APPLICATION NO.	FILING DATE	FIRST NAMED INVENTOR	ATTORNEY DOCKET NO.	CONFIRMATION NO.
10/517,902	12/15/2005	Johan Anton Eduard Rosenberg	9342-26	7031
54414	7590	05/03/2007	EXAMINER	
MYERS BIGEL SIBLEY & SAJOVEC, P.A. P.O. BOX 37428 RALEIGH, NC 27627			LE, TUNG X	
ART UNIT		PAPER NUMBER		
2821				
MAIL DATE		DELIVERY MODE		
05/03/2007		PAPER

Office Action Summary	Application No.	Applicant(s)	
	10/517,902	ROSENBERG ET AL.	
	Examiner	Art Unit	
	Tung X. Le	2821

DETAILED ACTION

FIG-2

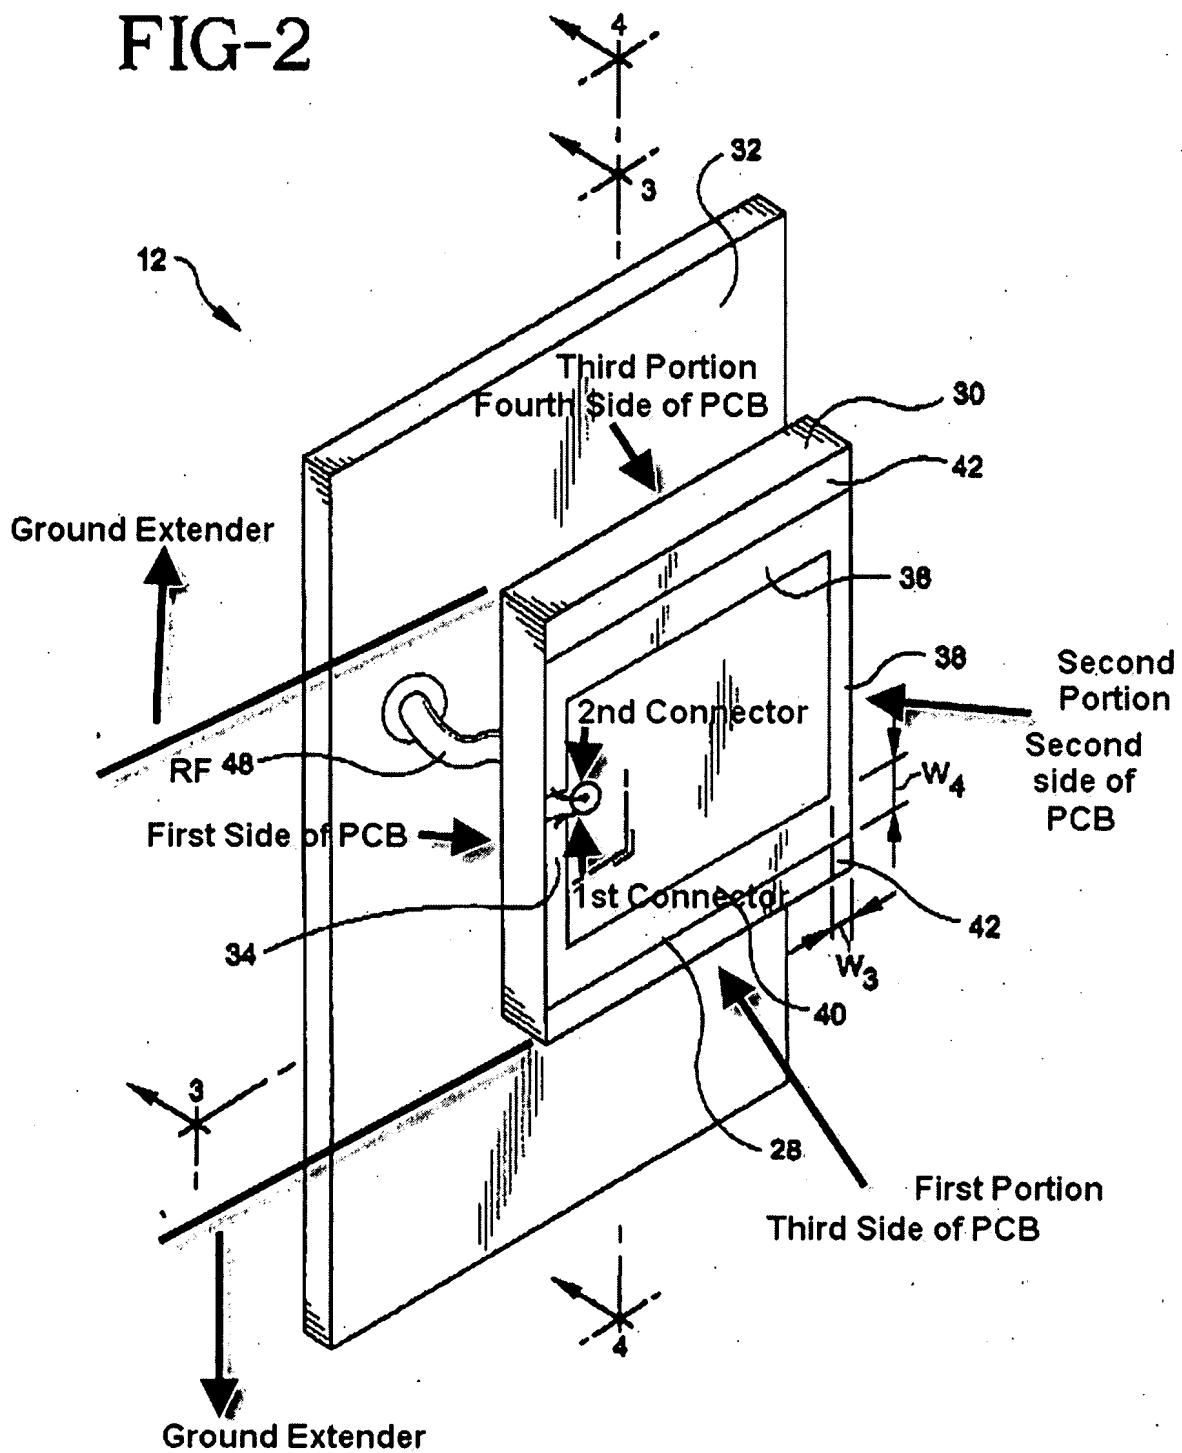
Regarding claim 1, Johson discloses in figures 1-2 an antenna for a portable device (10, 12) comprising an antenna loop (28) of conducting material (column 2, lines 61-67) having first and second ends (figure 2 shown the first and second connectors) connected to radio frequency (RF) circuit (48) and a ground plane (32) of a printed circuit board (20) (column 3, lines 60-65), respectively, the antenna loop (28) being positioned opposite the ground plane (figure 2); and a ground plane extender (figure 2 in the page 2 shown the ground extenders at the first side of the PCB) positioned at a first side (figure 2 in the page 2) of the printed circuit board and in a longitudinal extension of the ground plane (32), **wherein the ground plane extender is a separate piece from the ground plane** (the new subject matter is rejected in the above 112 first paragraph).

Regarding claim 2, Johson discloses in figures 1-2 and 4 that the antenna loop (28) comprises first and second connector (figure 2) provided at a second side (2) of the printed circuit board (20) configured to connect the first and second ends (1st and 2nd connectors) of the antenna loop (28) to the RF circuitry (48) and the ground plane (32) of the printed circuit board (20), respectively.

Regarding claim 3, Johson discloses in figure 2 (page 2) that the antenna loop (28) further comprises a first portion (3) having a first and a second end (figure 2), the first portion extending a first direction along a third side (3) of the printed circuit board (20), the first end of the first portion being connected to the radio frequency circuitry (48) of the printed circuit board (20); a second portion (2) having a first and a second end, the first end of the second portion (2) being connected to the second end of the first portion (3), the second portion extending in a second direction from the third side (3) of the printed circuit board (20) towards a fourth side (4) thereof, which is opposite the third side (3); and a third portion (4) having a first and a second end (figure 2) of the second portion (2) and the second end of the third portion being connected to the ground plane (32) of the printed circuit board (20), the third portion (4) extending in the opposite direction of the first direction along the fourth side (4) of the printed circuit board (20).

Regarding claims 1 and 11-12, Applicant argues that Johson does not teach or suggest first and second ends are connected to a radio frequency circuitry and a ground plane of a printed circuit board, respectively. However, Examiner disagrees since Johson clearly discloses first and second ends (having a first and second ends at the 1st

Connector and 2nd connector shown in the figure 2 copy) are connected to a radio frequency circuitry (RF coax line [48]) and a ground plane (32) of a PCB (20) (having the radio frequency [48] connected between the loop antenna [28] at the first and second connectors and the printed circuit board [20] in order for receiving or transmitting signals between the circuit board and the antenna) (see column 1, lines 48-58 and column 2, lines 45-49).

Regarding claim 16, Applicant argues that Johson does suggest no direct connection between the antenna loop and any radio frequency circuitry. However, Examiner disagrees since the antenna loop (28) directly connected with the RF circuitry (48) as clearly shown in the copied figure in the office action.
